MIL-M-28787/116A
AMENDMENT 2
31 December 1992
SUPERSEDING
AMENDMENT 1
14 November 1983

MILITARY SPECIFICATION

MODULES, STANDARD ELECTRONIC

GATE, NAND, DIGITAL, KEY CODE BDC

FIGURE 5 Zener applied potential test circuit for table III.

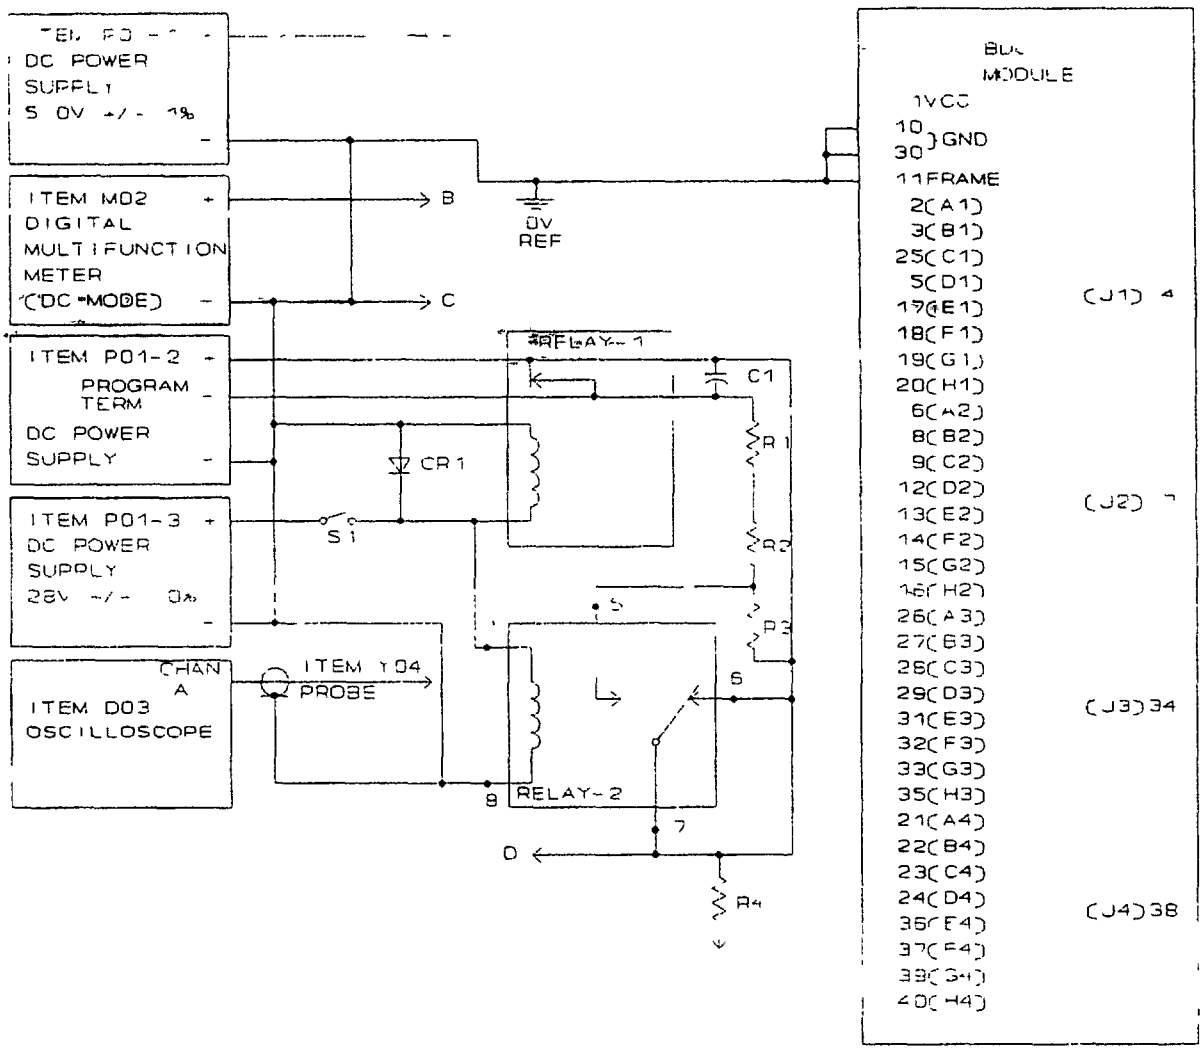
FIGURE 5: Delete and substitute new figure 5 as printed on page 3 of this amendment.

CAUTION: If these tests are successively repeated, a time interval of 10 seconds minimum between tests shall be allowed to preclude detrimental effects due to module heating.

FIGURE 7 VOUT (low loaded) test circuit for table IV

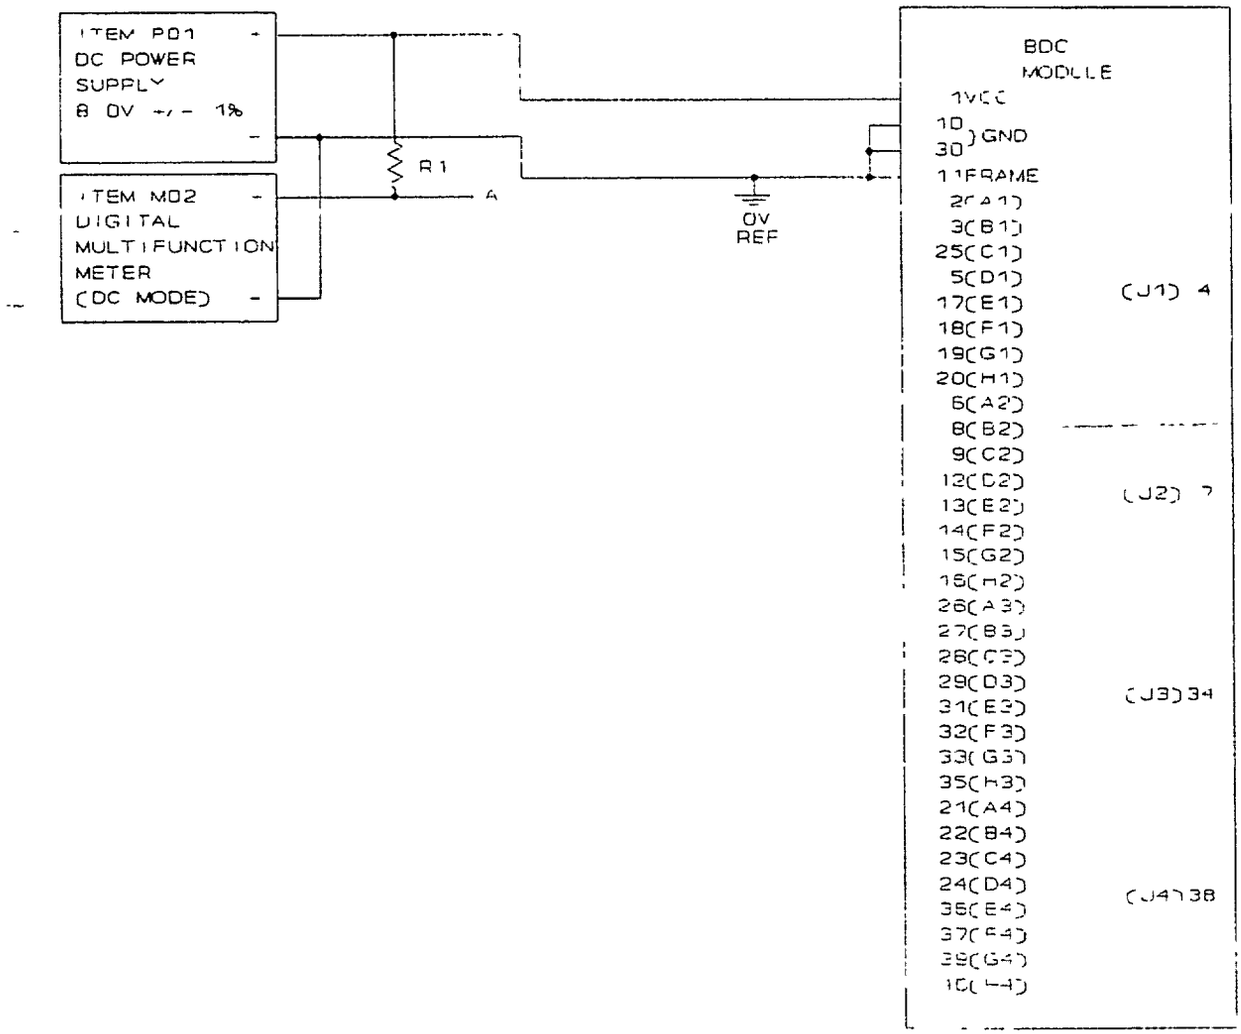
FIGURE 7: Delete and substitute new figure 7 as printed on page 4 of this amendment.

CAUTION: If these tests are successively repeated, the time interval between execution should be a minimum of 10 seconds in order to preclude detrimental effects due to module heating.

NOTES: 1. R1 = 261 Ω ± 1%, 1/2 W.
2. After point A has been connected to the appropriate module pin, the output shall be monitored for a minimum of 10 seconds before taking the measurement

FIGURE 9. Output voltage (high-level and low-level) test circuit for table VI.

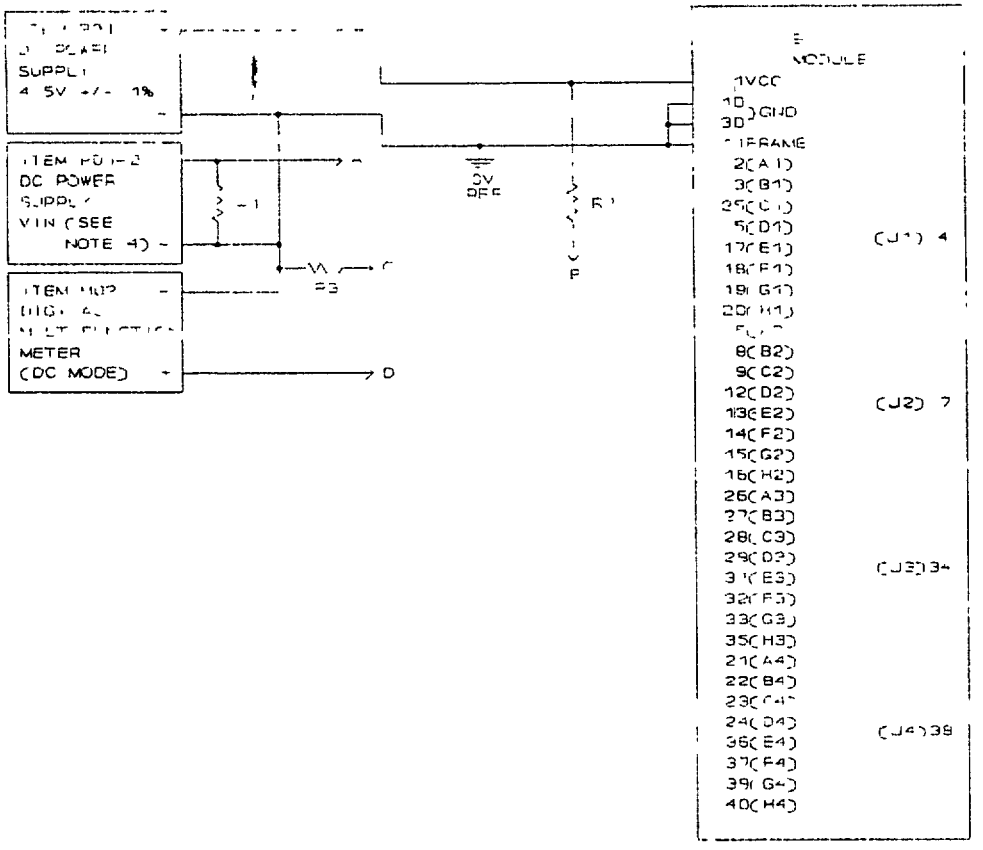
FIGURE 9: Delete and substitute new figure 9 as printed on page 5 of this amendment.

NOTES:
1. R1 = 127 Ω ± 1%, 1/8 W.
2. R2 = 348 Ω ± 1%, 1/8 W.
3. R3 = 61.9 kΩ ± 1%, 1/8 W.
4. Use appropriate VIN for specified test condition and temperature listed below:

Test condition	Temperature (°C)	VIN (volts)
E1-E32	0	1.20
	25	1.10
	60	0.95
	80	0.80
F1-F4	0	2.0
	25	1.9
	60	1.8
	80	1.8

0°, 60°, and 80°C refer to operating temperatures (module frame); 25°C refers to ambient temperature. For 80°C use the 0° to 60°C end-of-life limits
